UNITED STATES PATENT AND TRADEMARK OFFICE

APPLICATION NO.	FILING DATE	FIRST NAMED INVENTOR	ATTORNEY DOCKET NO.	CONFIRMATION NO.
10/578,321	05/04/2006	Takenori Yoshizawa	1248-0870PUS1	5572

Office Action Summary	Application No.	Applicant(s)	
	10/578,321	YOSHIZAWA, TAKENORI	
	Examiner	Art Unit	
	Stanton L. Krycinski	3637

DETAILED ACTION

Figure 7. Pakeriasamy (US Patent No. 5,957,293).

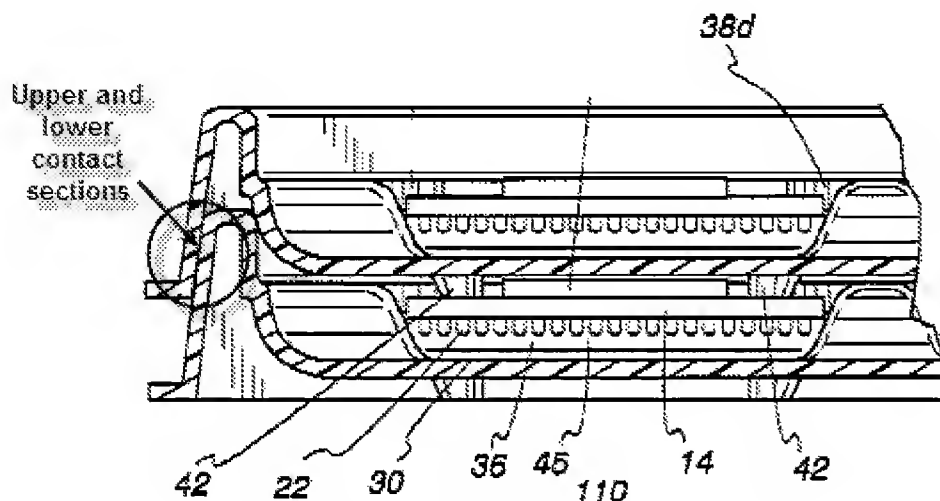
14. In regards to Claim 1, Pakeriasamy teaches a *stackable substrate carrying tray* (11b, Figure 1) *on which a substrate* (12, Figure 1) *is placed horizontally* (Column 2, Lines 12-16), *so as to be separated from an upper stacked substrate carrying tray* (11a, Figure 1) (Column 4, Lines 51-56), *comprising:*

an upper contact section; and

a lower contact section (upper and lower contact sections illustrated in Figure 7 above),

the upper contact section contacting, by areal contact (line contact), a first substrate carrying tray (11a) *which is stacked above said substrate carrying tray* (11b)

with the substrate (12) placed thereon and the lower contact section contacting, by areal contact, a second substrate carrying tray (any number of trays can be stacked, Column 5, Lines 20-23; although Figure 7 does not show a lower substrate carry tray stacked below, it is assumed that there is one below) which is stacked below said substrate carrying tray (11b) with the substrate (12) placed thereon.

15. Pakeriasamy teaches a stackable substrate tray that is nested upon adjacent substrate trays as shown in Figure 7. Therefore, Pakeriasamy's stackable substrate tray is considered to have *the upper and lower contact sections being formed in a shape so as to move, when the first stackable substrate carrying tray (11a) is stacked above said substrate carrying tray (11b), the first substrate carrying tray (11a) in such a direction that a center of gravity of the first substrate carrying tray (11a) is positioned vertically above a center of gravity of said substrate carrying tray (11b).*

Figure 7. Pakeriasamy (US Patent No. 5,957,293).

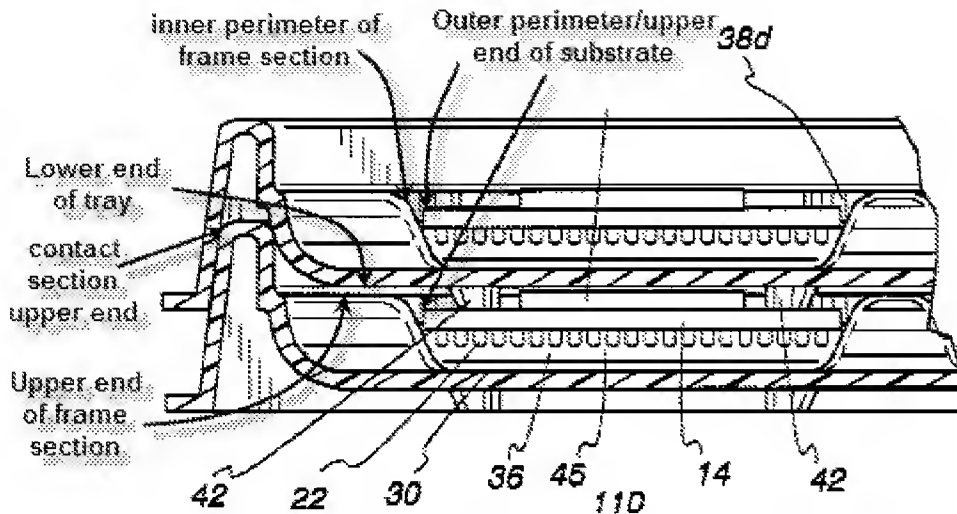
25. In regards to Claims 29 and 30, Pakeriasamy teaches *the loading bed (28, Figure 2) includes a frame section (32a-32d, Figure 2) whose inner perimeter is larger than an outer perimeter of the substrate (12, Figure 1) (the top rim of the frame section has an inner perimeter larger than the outer perimeter of the substrate as illustrated in Figure 7 above).*

26. In regards to Claims 35 and 36, Pakeriasamy teaches *the frame section (32a-32d, Figure 2) of the loading bed (28, Figure 2) has such a shape that there is a space between a lower end of the first substrate carrying tray (11a, Figure 7) and an upper end of the frame section (32a-32d) (as illustrated in Figure 7 above).*

27. In regards to Claims 38 and 39, Pakeriasamy teaches *an upper end of the frame section (32a-32d, Figure 2) of the loading bed (30, Figure 2) is lower than an upper end of the upper contact section and higher than an upper end of the substrate (14, Figure 2) placed on the substrate carrying tray (11b, Figure 1) (as illustrated in Figure 7 above).*

Figure 9. Irwin (US Patent No. 1,941,941).

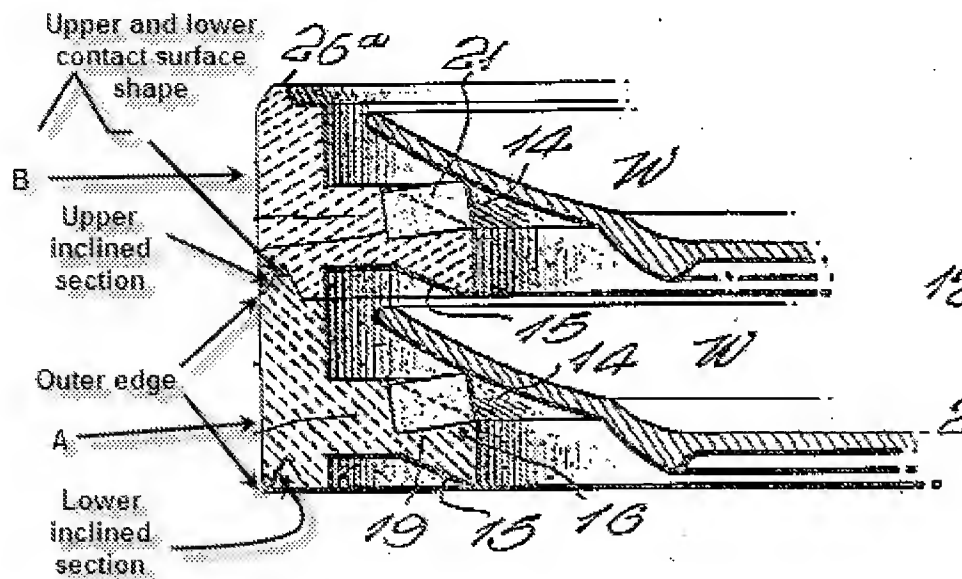
30. In regards to Claim 1, Irwin teaches a *stackable substrate carrying tray* (one embodiment shown entirely in Figure 2; illustrated as A in Figure 9 above) *on which a substrate* (W, Figure 1) *is placed horizontally* (Column 2, Lines 12-16), *so as to be separated from an upper stacked substrate carrying tray* (as shown in Figure 1, 8 and 9, Column 3, Lines 5-9), *comprising:*

the lower contact section (27a) including a lower inclined section, for the areal contact, which has a same inclined direction as that of the upper inclined section (inclined sections illustrated in Figure 9 above).

34. In regards to Claims 5 and 12, Irwin teaches *the upper inclined section is provided on a portion including an outer edge or inner edge of an upper surface of the upper contact section (26a, Figure 9), and the lower inclined section is provided on a portion of the lower contact section (27a, Figure 9), the portion including an edge corresponding to an edge on which the upper inclined section is disposed (as illustrated in Figure 9 above).*

38. In regards to Claim 48, Irwin teaches *the upper contact section (26a, Figure 9) contacting the first substrate carrying tray which is stacked above said substrate carrying tray by only the surface of the upper contact section (26a) and the lower contact section (27a, Figure 9) contacting the second substrate carrying tray which is stacked below said substrate carrying tray by only the surface of the lower contact section (27a), and wherein the surface of the upper contact section (26a) and the surface of the lower contact section (27a) have the same surface area, the same shape (triangular with flat side), and the same inclination (as illustrated in Figure 9 above; the figure shows two trays, although multiple trays can be stacked).*

Figure 7. Irwin (US Patent No. 1,941,941).

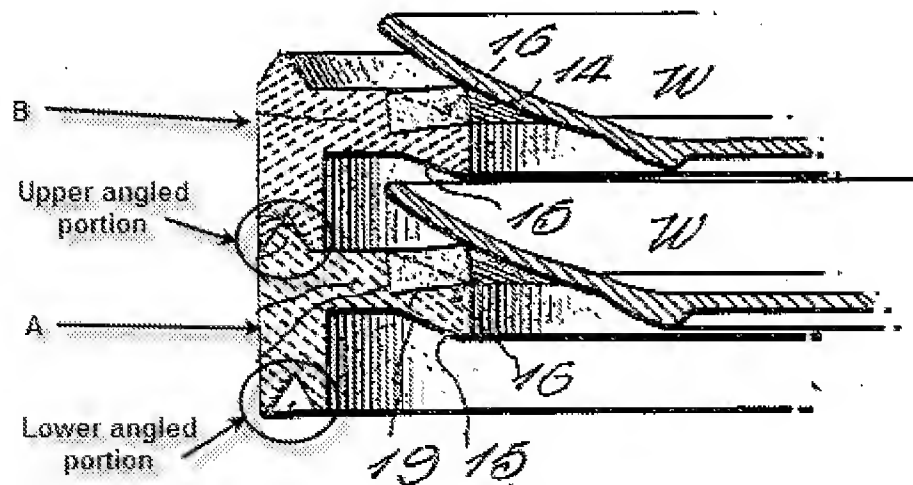
37. In regards to Claims 47, Irwin teaches *the upper contact section (26a, Figure 7) contacting the first substrate carrying tray which is stacked above said substrate carrying tray by only an angled portion of the upper contact section (26a) and the lower contact section (27a, Figure 7) contacting the second substrate carrying tray which is stacked below said substrate carrying tray by only an angled portion of the lower*

contact section (27a), and wherein the angled portion of the upper contact section and the angled portion of the lower contact section have equal width and the same inclination (the contact sections are entirely angled portions as illustrated in Figure 7 above in an embodiment of the contacting sections; the figure shows two tray, although multiple trays can be stacked).

Figure 7. Pakeriasamy (US Patent No. 5,957,293).

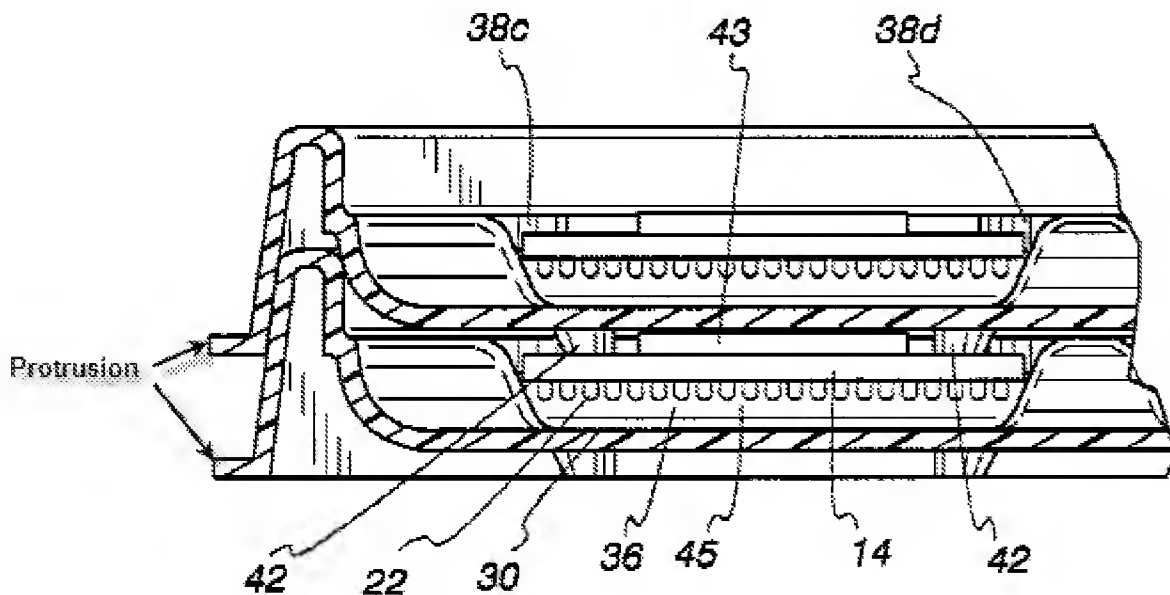
44. In regards to Claim 9, Pakeriasamy teaches a protrusion (as illustrated in Figure 7 above) that is capable of engaging a chuck for catching the tray (11b, Figure 7), wherein the protrusion is different from the upper and lower contact sections. The protrusion is an extension of the outside of the peripheral edge (26a-26d, Figure 1) with space between adjacent protrusions as shown in Figure 7, therefore a chuck is considered capable of engaging the protrusions.

45. In regards to Claims 32 and 33, Pakeriasamy teaches a substrate carrying tray (11b, Figure 7) with stand-offs (42, Figure 7) that engage the top surface of the substrate (14, Figure 7). However, Pakeriasamy teaches the stand-off structure (42) as an improvement of prior art substrate carrying trays wherein the stand-offs are omitted (Column 4, Lines 40-55).

46. It would have been obvious to one of ordinary skill in the art at the time the invention was made to modify Pakeriasamy's tray to have *the frame section (32a-32d, Figure 2) of the loading bed (30, Figure 2) has such a shape that the first substrate carrying tray (11a, Figure 7) is not in contact with the substrate (14, Figure 7) when the substrate (14) is placed on said substrate carrying tray (11b, Figure 7), as a matter of obvious design choice.*

Figure 5. Cristy et al. (US Patent No. 3,695,424).

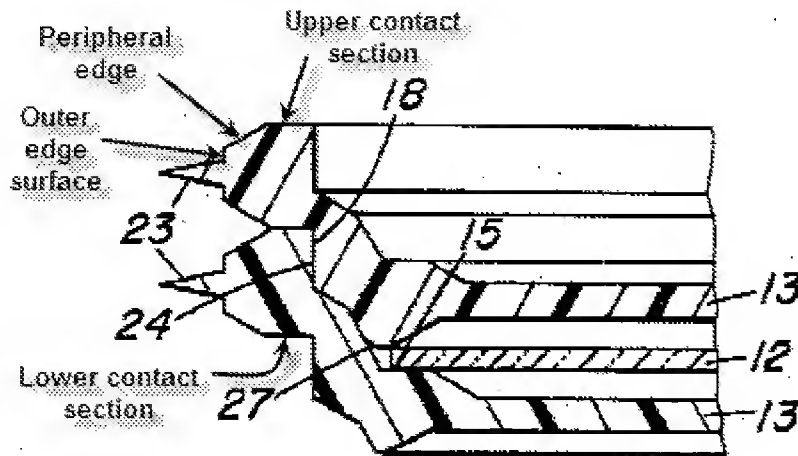
49. Cristy et al. teaches a stackable substrate carrying tray (11, Figure 1), wherein *the tray (11) includes a protrusion (23, Figure 5) that is capable of engaging a chuck for catching the tray (11), the protrusion (23) outwardly protruding from an outer edge surface of the peripheral edge of the tray (11), the outer edge surface is formed, in a plane manner, in such a direction that becomes a vertical direction when the tray (11) is placed horizontally, and the upper and lower contact sections are provided inwardly from the outer edge surface (as illustrated in Figure 5 above).*

50. It would have been obvious to one of ordinary skill in the art at the time the invention was made to modify Irwin's tray to have a protrusion on the peripheral edge capable of engaging a chuck as addressed above, for the purpose of allowing the trays

to be grasped and separated from each other as suggested by Cristy et al. (Column 5, Lines 2-5).
